Docket Number:	23-AFC-01
Project Title:	Morton Bay Geothermal Project (MBGP)
TN #:	253082
Document Title:	Morton Bay Geothermal Project Data Request Response Set 1 (Revised Responses to Data Requests 3, 4, 7, 10 to 13, and 73 to 77)
Description:	N/A
Filer:	Lindsey Xayachack
Organization:	Jacobs
Submitter Role:	Applicant Consultant
Submission Date:	11/13/2023 4:09:27 PM
Docketed Date:	11/13/2023

Data Response Set 1 (Revised Responses to Data Requests 3, 4, 7, 10 to 13, and 73 to 77)

Morton Bay Geothermal Project
(23-AFC-01)

November 10, 2023

Figure 5.9-2
Operations Cancer Risk Isopleths
Morton Bay Geothermal Project
 Imperial County, California

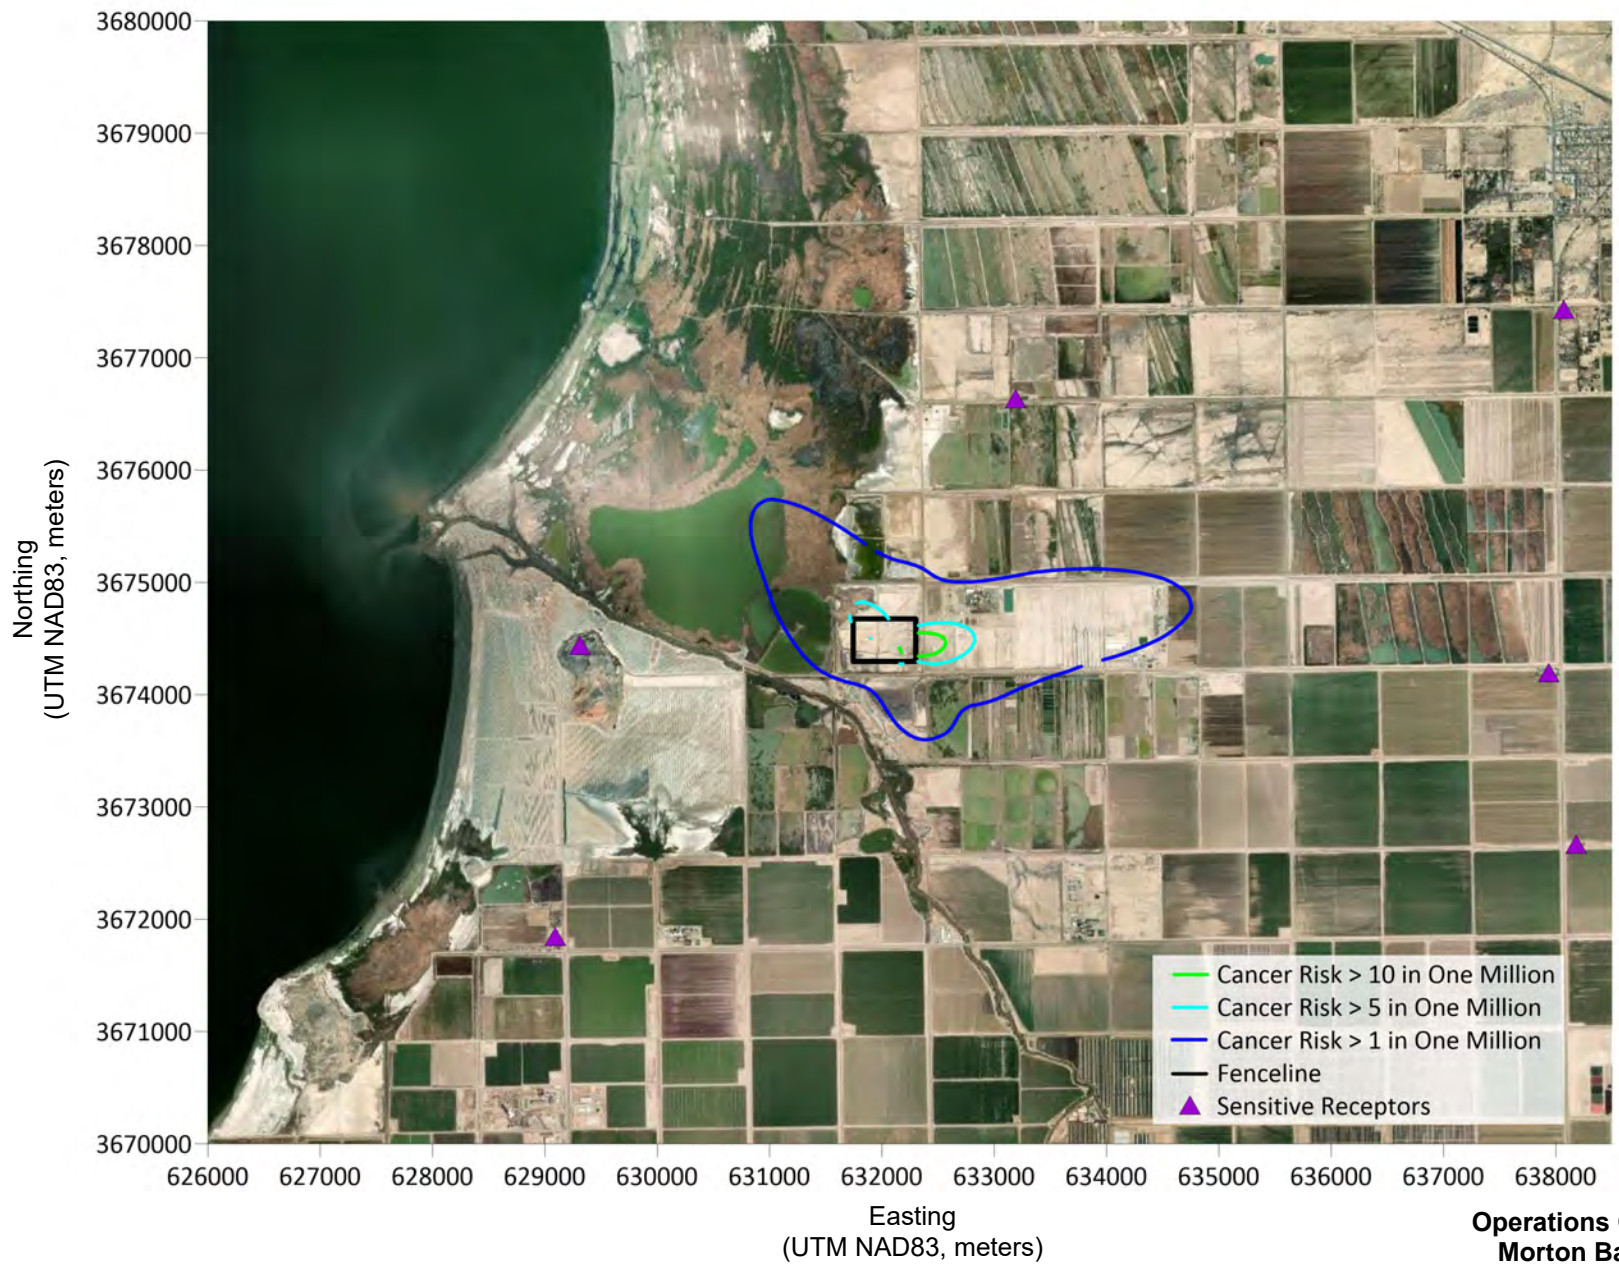
75. For residential exposures, please provide a map containing health risk isopleths, including an isopleth showing the risk value of 10 in a million.

Response: A map containing cancer risk isopleths reflective of the revised operational HRA modeling, including isopleths showing the risk values of 1, 5, and 10 in a million, is included as new Figure 5.9-2 of revised Section 5.9 from the AFC, which is included with this DRR as Attachment DRR 7-2. Additionally, Appendix 5.9A has been revised to incorporate refinements to the MBGP design. A spreadsheet version of revised Appendix 5.9A is included with this DRR as Attachment DRR 75-1.

Figure 5.9-4
Construction Cancer Risk Isopleths
Morton Bay Geothermal Project
 Imperial County, California

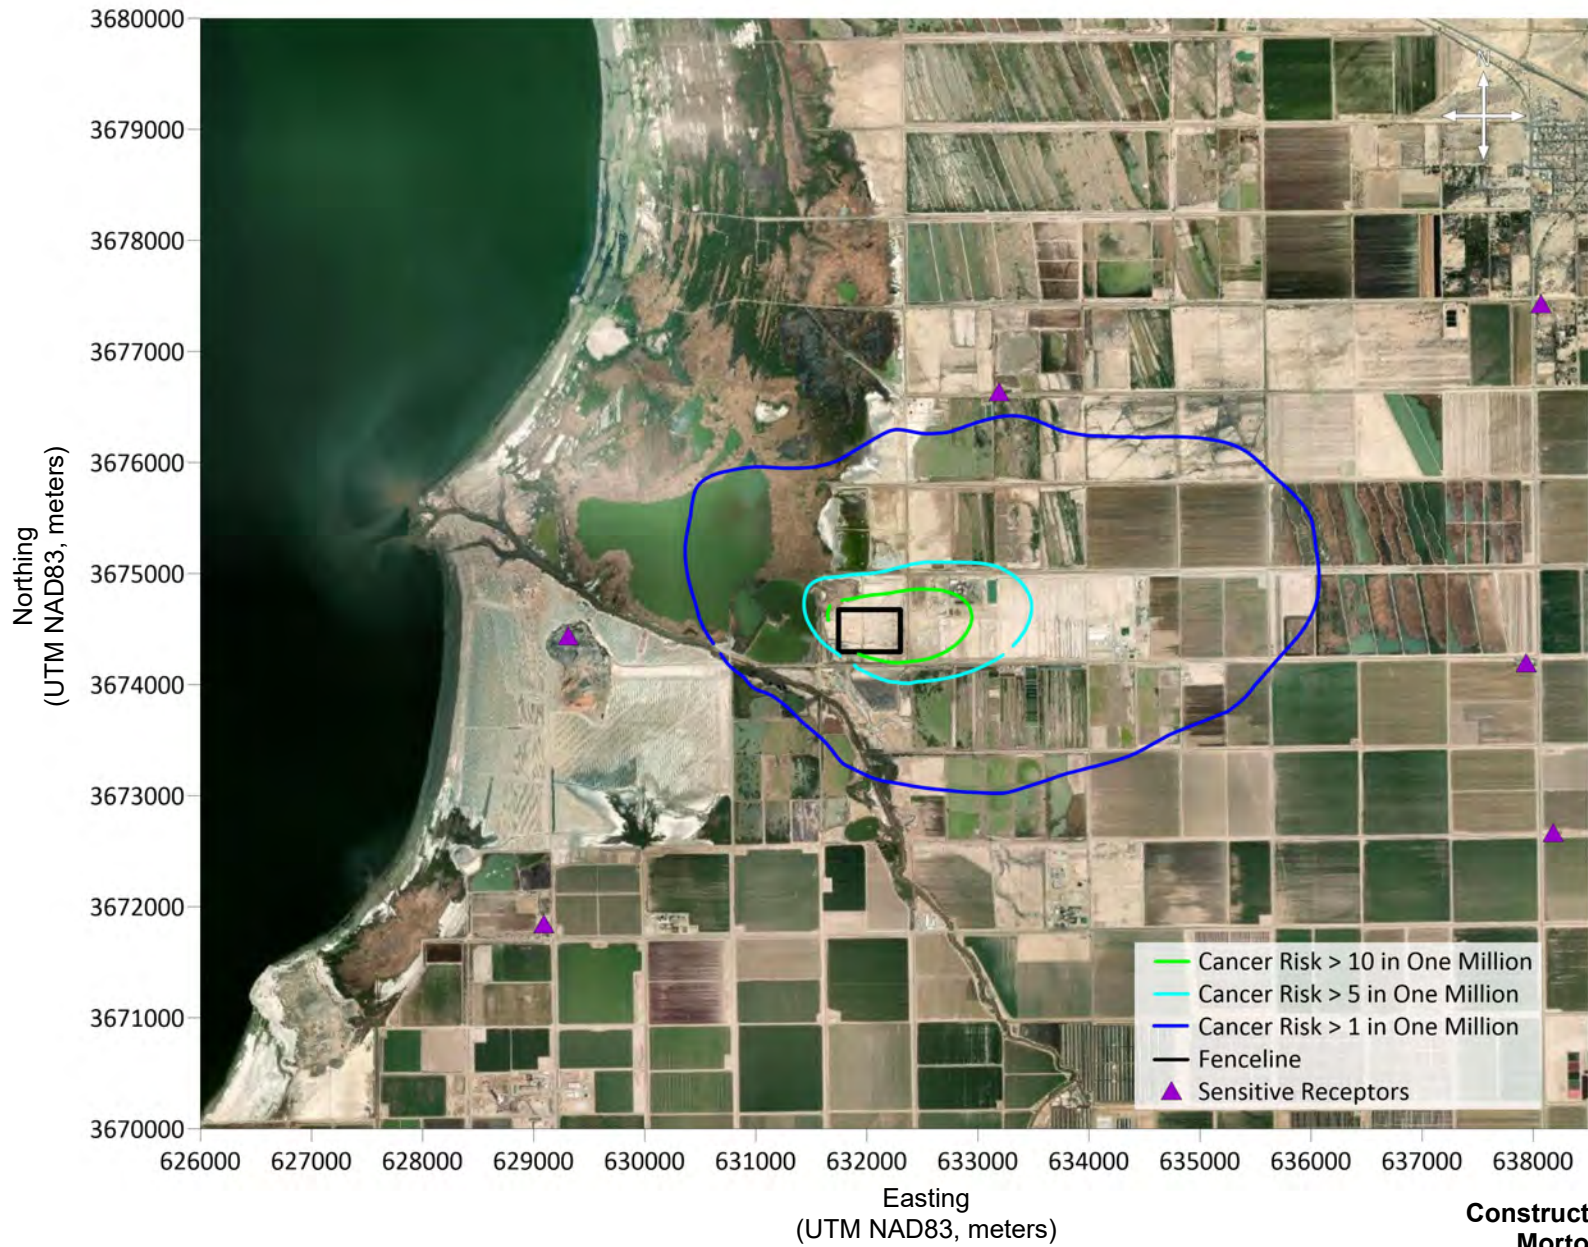
74. For residential exposures, please provide a map containing health risk isopleths, including an isopleth showing the risk value of 10 in a million.

Response: A map containing cancer risk isopleths reflective of the revised construction HRA modeling, including isopleths showing the risk values of 1, 5, and 10 in a million, is included as new Figure 5.9-4 of revised Section 5.9 from the AFC, which is included with this DRR as Attachment DRR 7-2.
